ADDENDUM #2

PROJECT: Bridge Classroom Portable & Relocated Portable at Lawrence ES
Lodi Unified School District

REF. # : District Project No. #2600-5870-210-60
DSA FILE # 39-50
Lawrence ES

DATE : January 21, 2026

ELECTRICAL PLAN

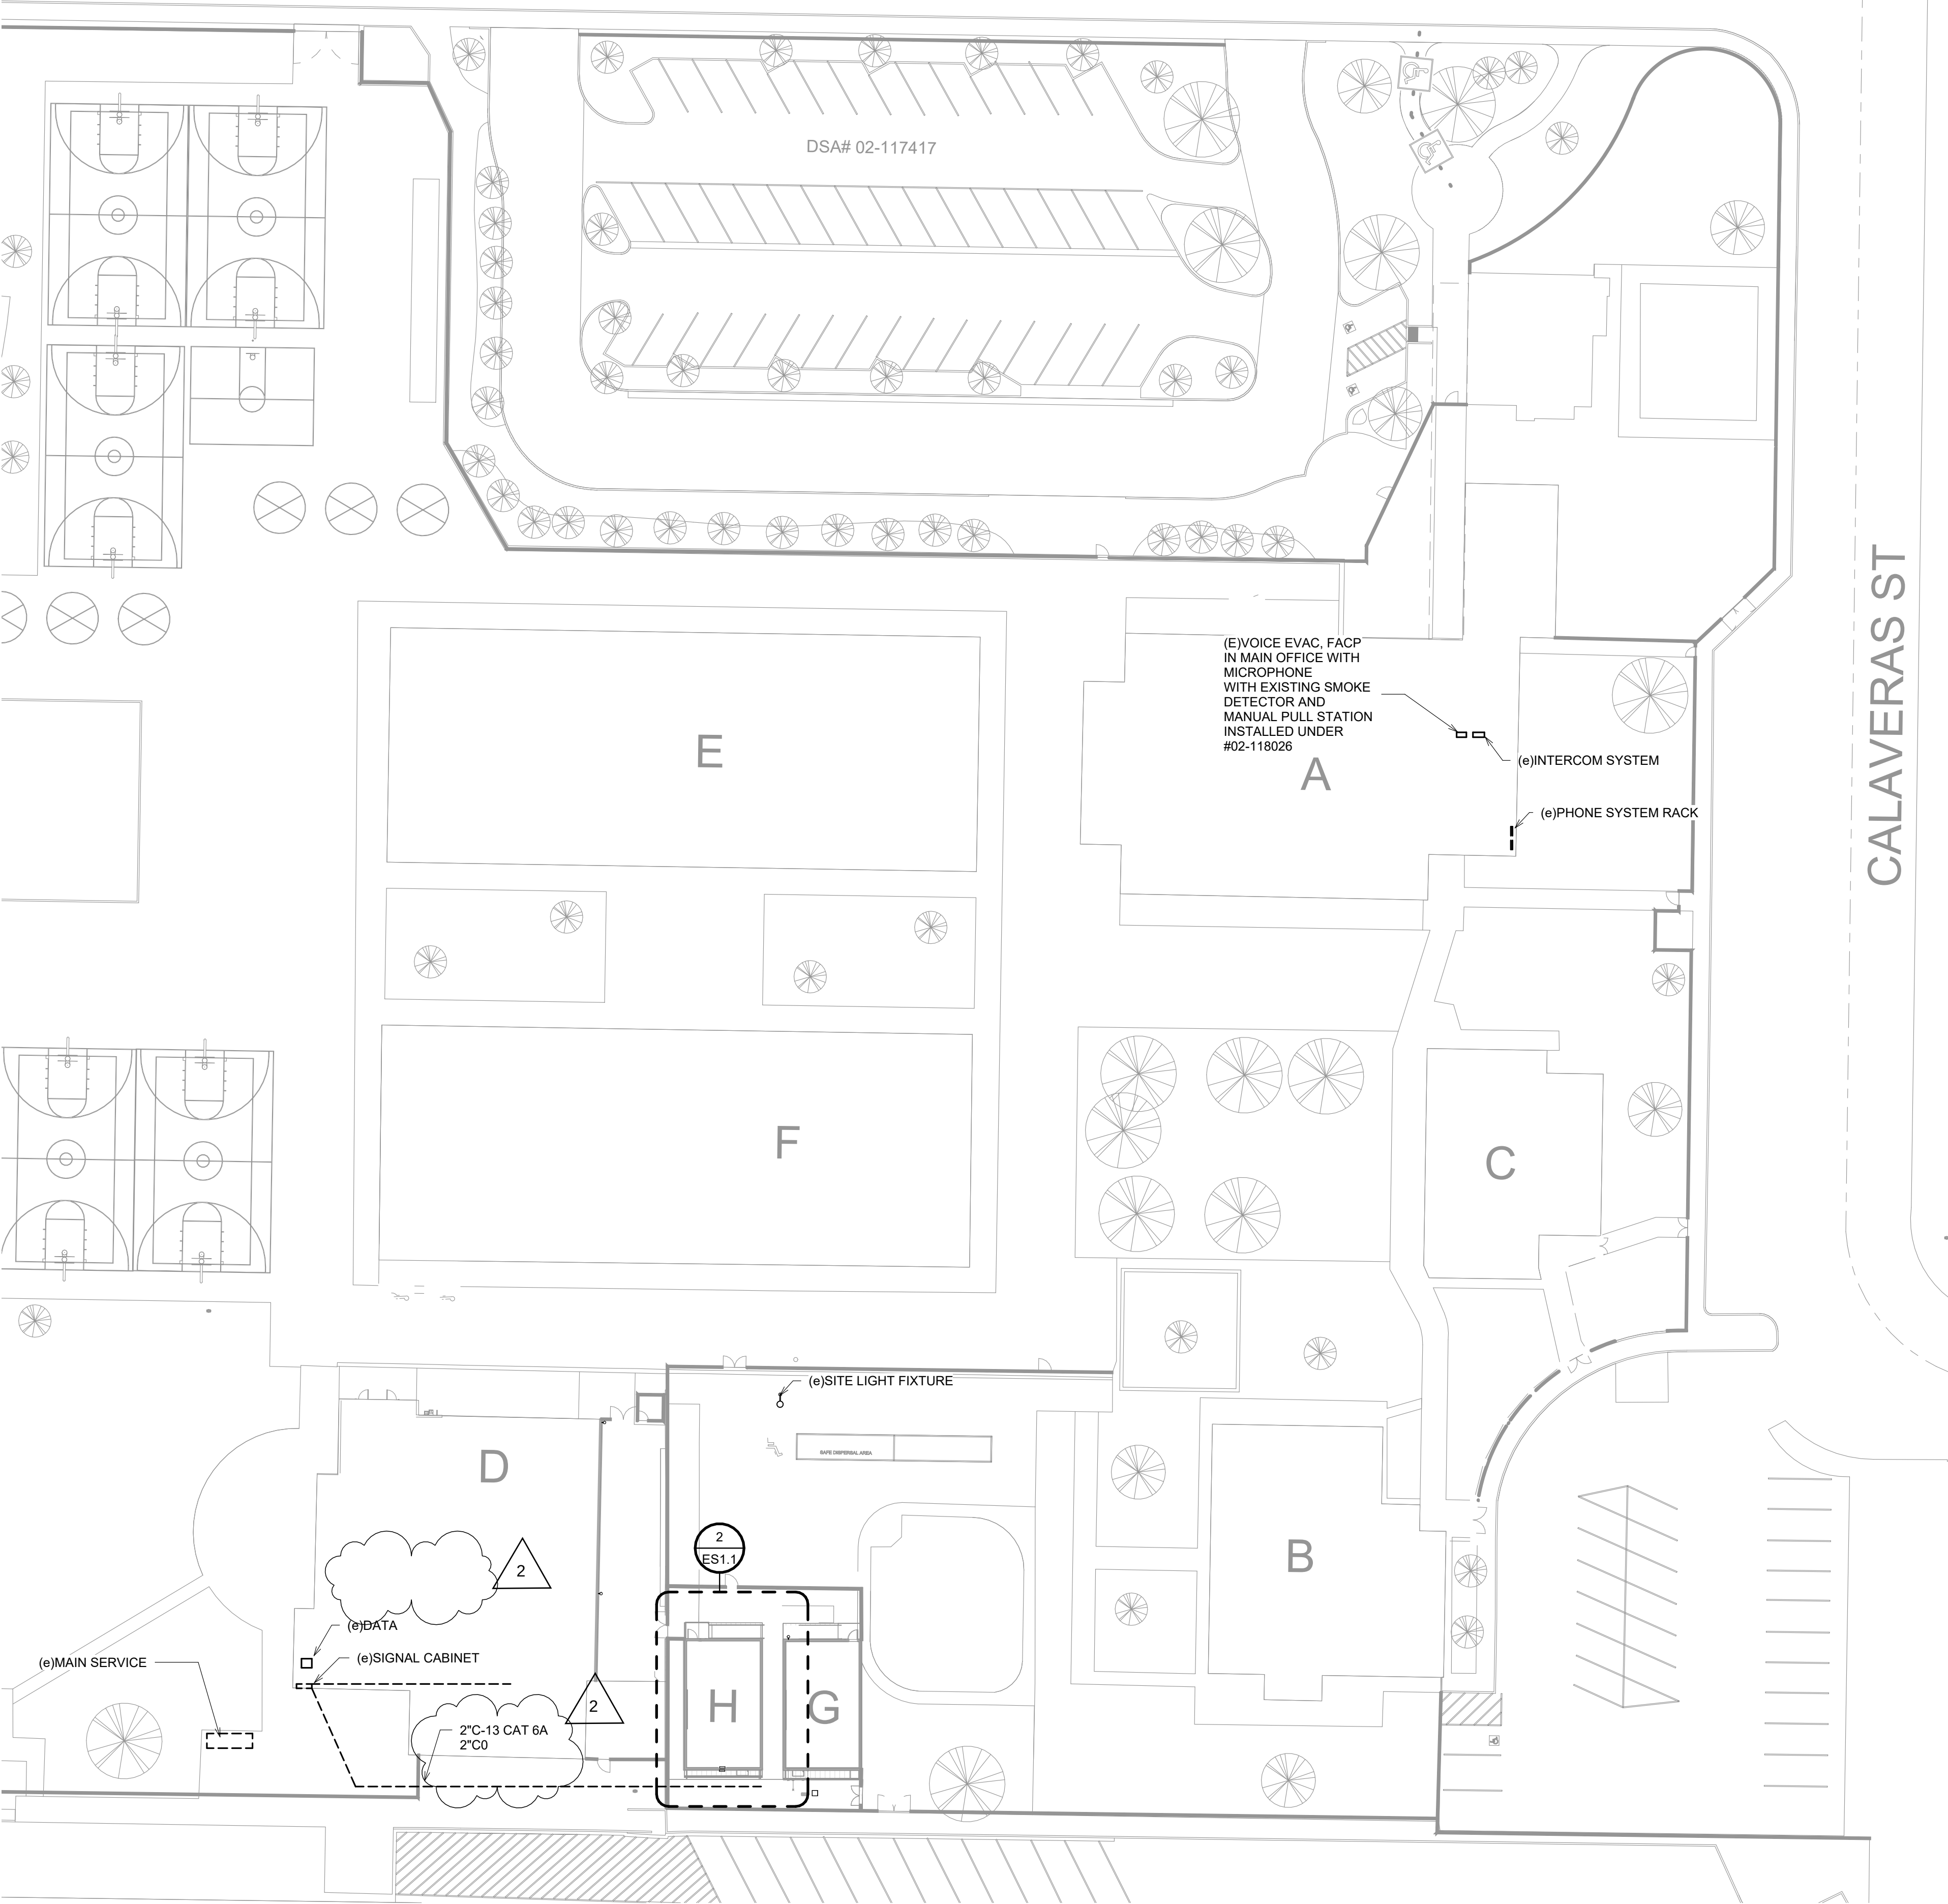
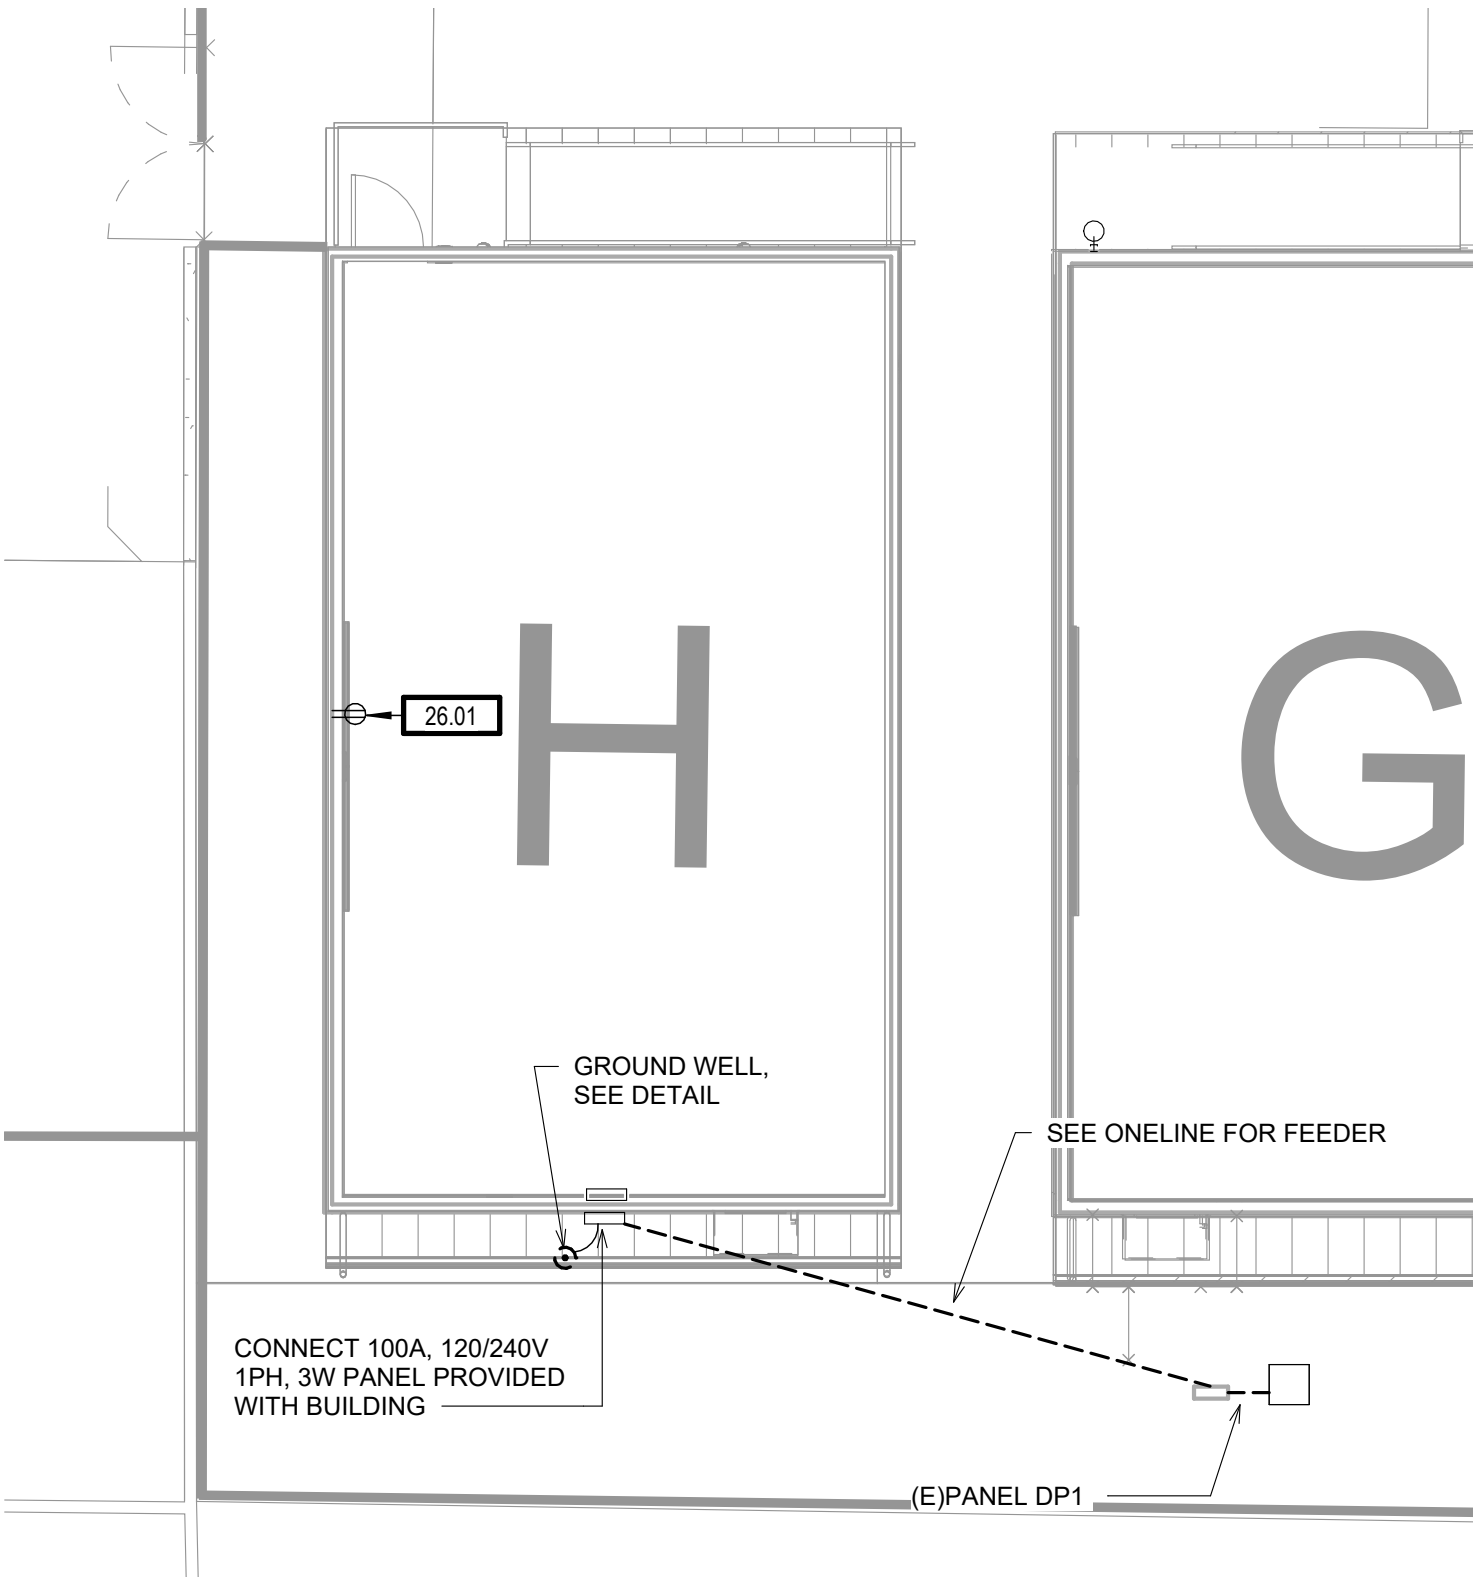
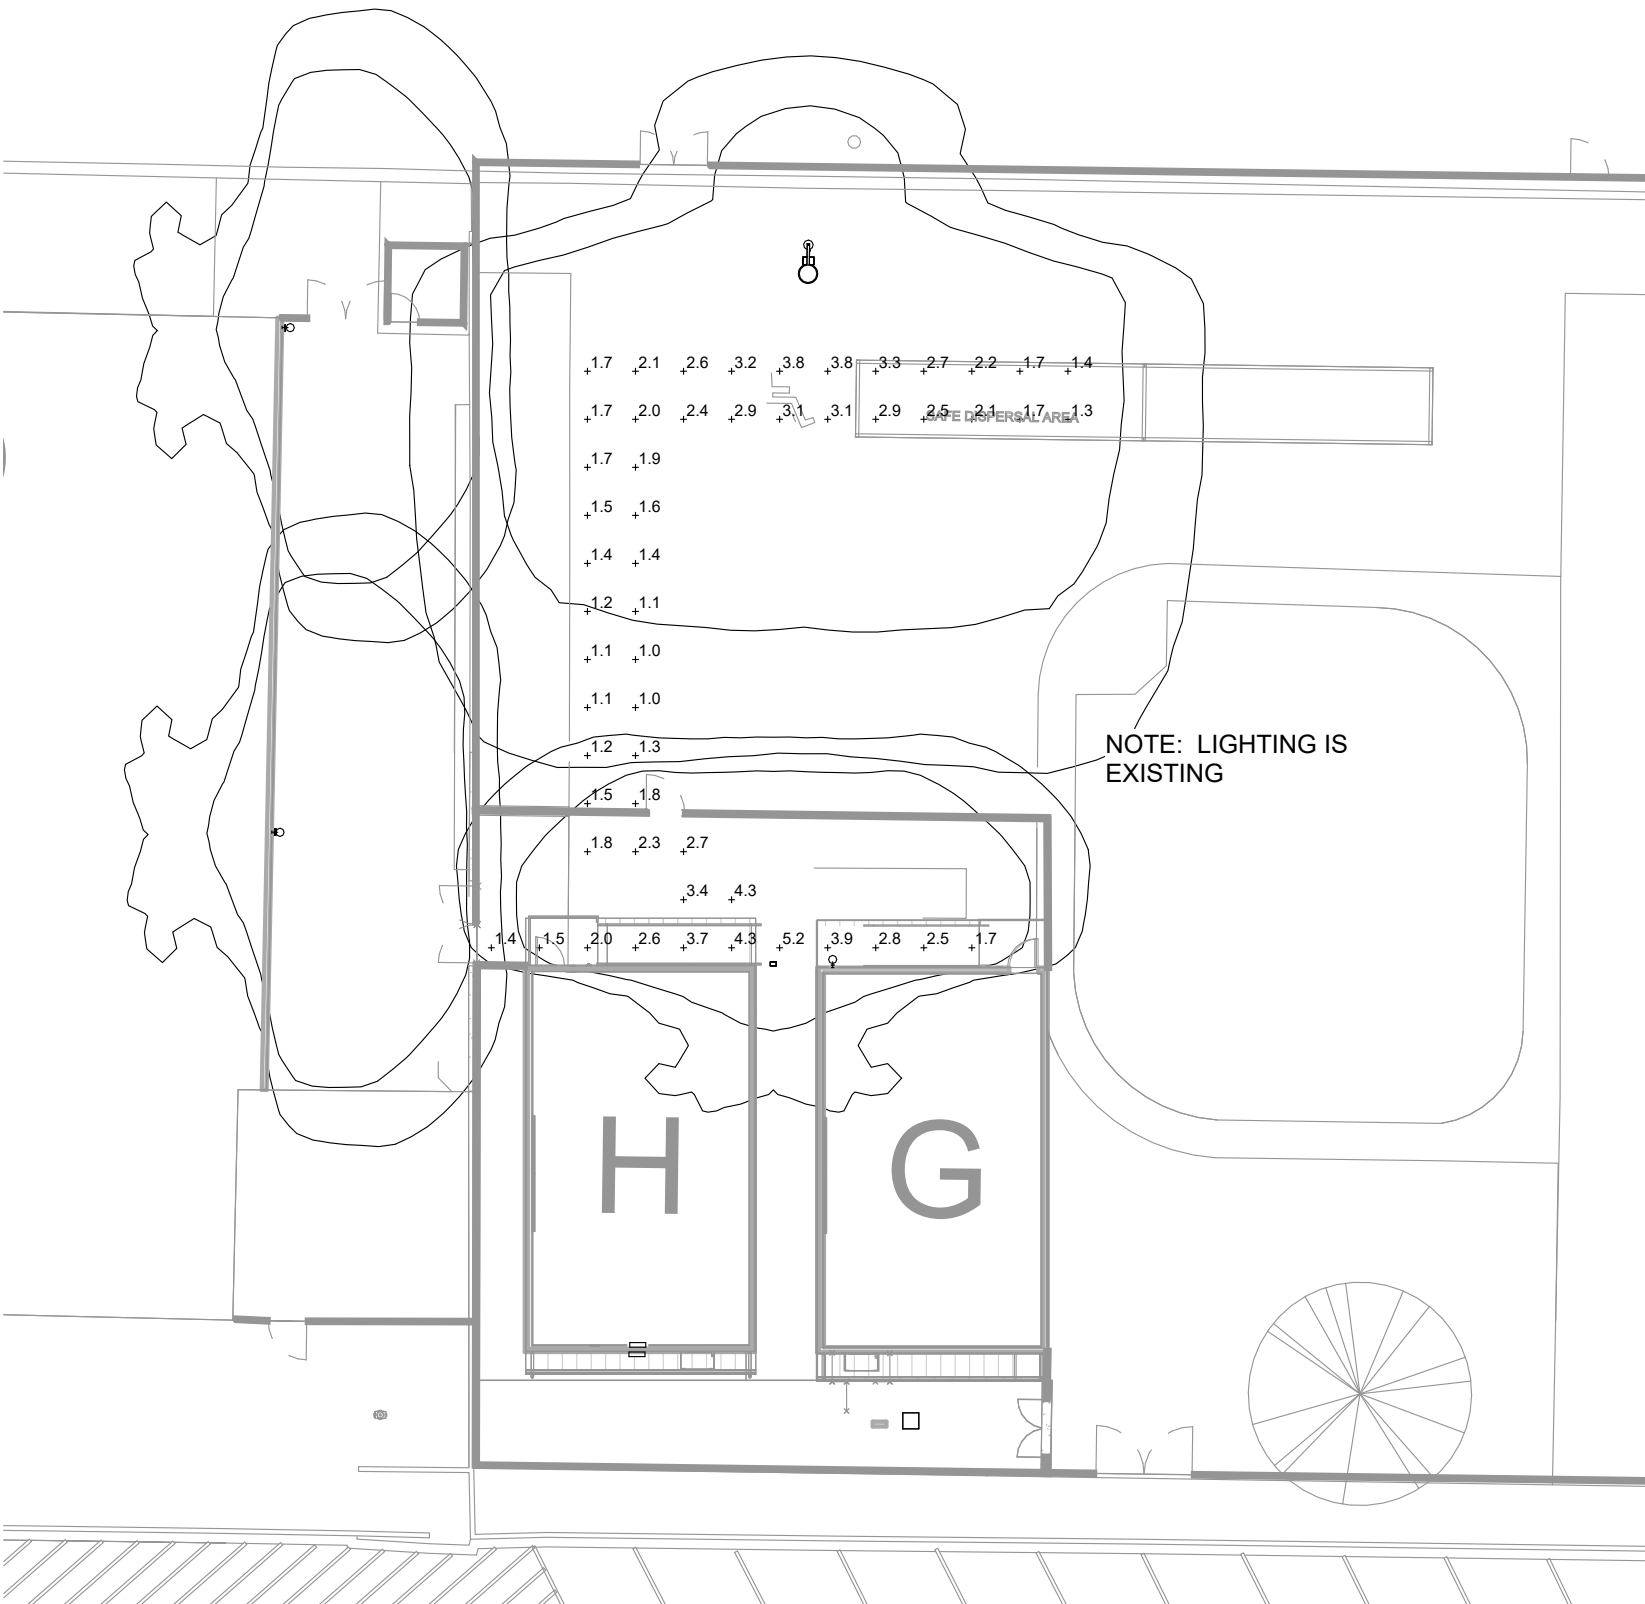
ITEM 1 Provide CAT 6A wiring for phones, data, and intercom systems

All wiring used in the Bridge Portable Classroom building (Unit G) and Relocated Portable (Unit H) at Lawrence Elementary School projects are to be CAT 6A wiring as described on the attached revised sheets 1-ES1.1 and 1-ES2.1 of the DSA approved drawings #02-123434 and #02-123755. Contractor to provide wiring and connections of phone, data, and intercom systems to each building. The District will provide and install the Jive phone/intercom system.
